REMARKS

The Rejections:

Fig. 2

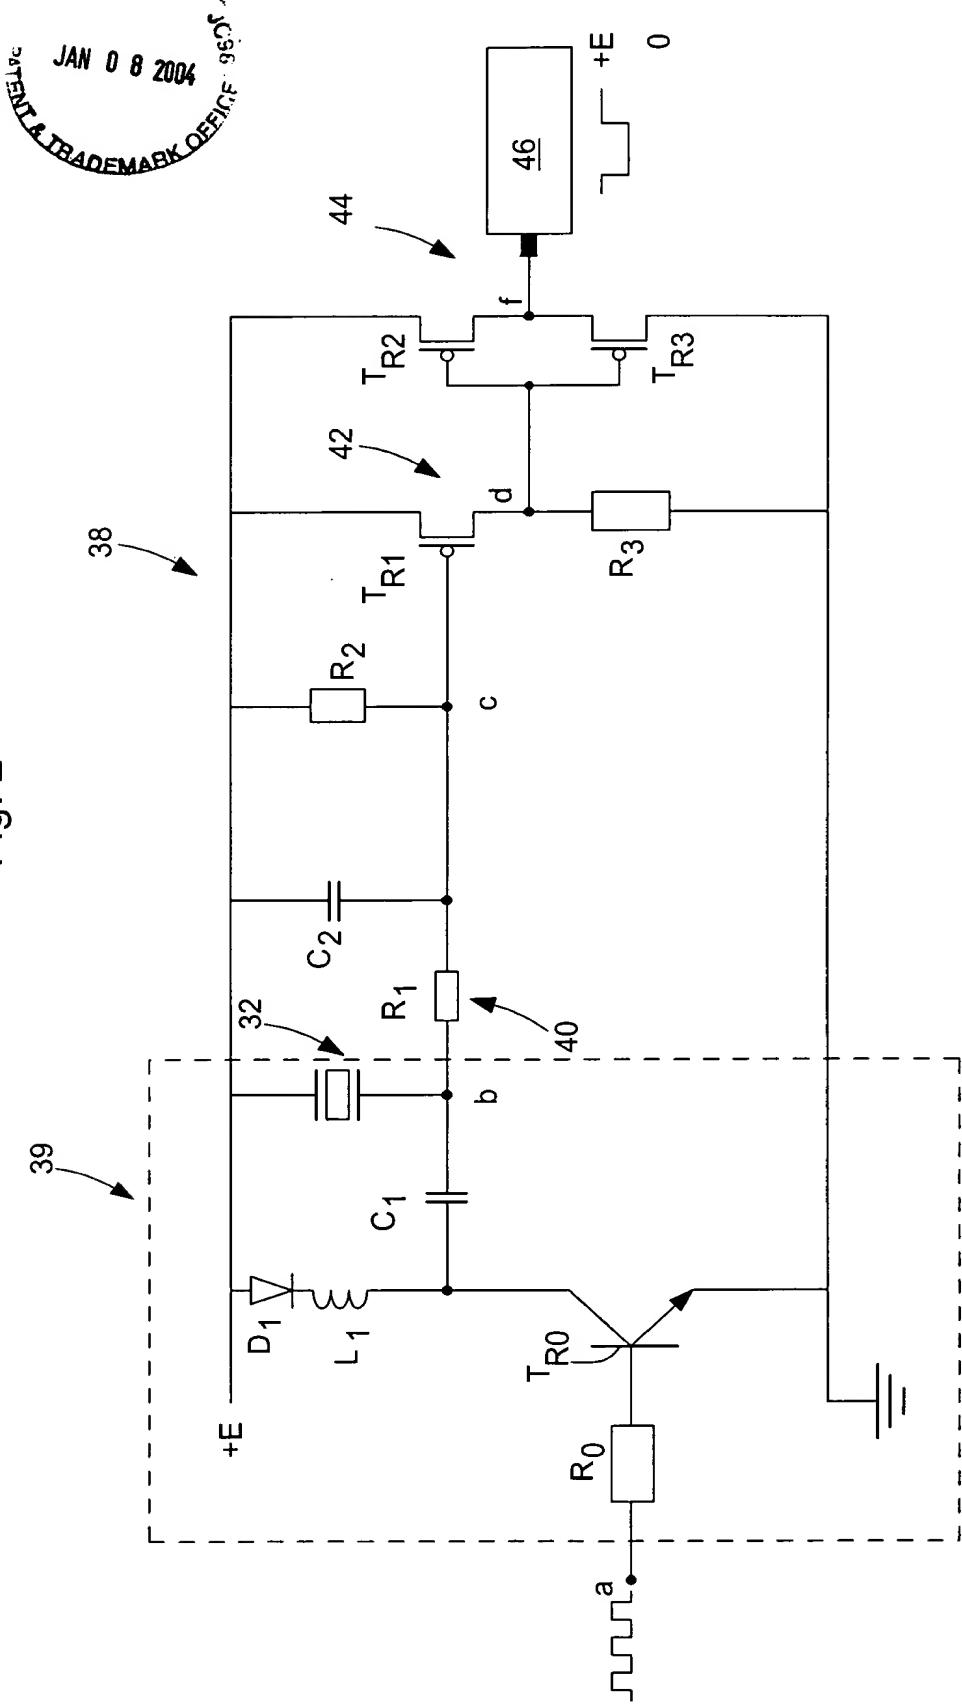
Fig. 2 has been amended, as discussed above, to include new drawing Fig. 2 includes a box referenced 46 located at connection point "f" that comprises the output of conversion stage 44. This amendment is supported at page 8, lines 12-15 of the specification. Line 15 of page 8 of the specification has been amended accordingly. Amended Fig. 2 also includes a diode designated by D₁ has also been represented on new drawing figure 2, this diode being mounted in series with coil L₁. This amendment is supported at page 5, lines 32-34 of the original specification. Line 33 of page 5 of the specification has been amended accordingly.

The drawings stand objected to under 37 C.F.R. 1.83(a), for failing to disclose the microprocessor, the second electronic circuit, and the diode. The amended Fig. 2 is believed to overcome these objections and withdrawal of the rejection is respectfully requested.
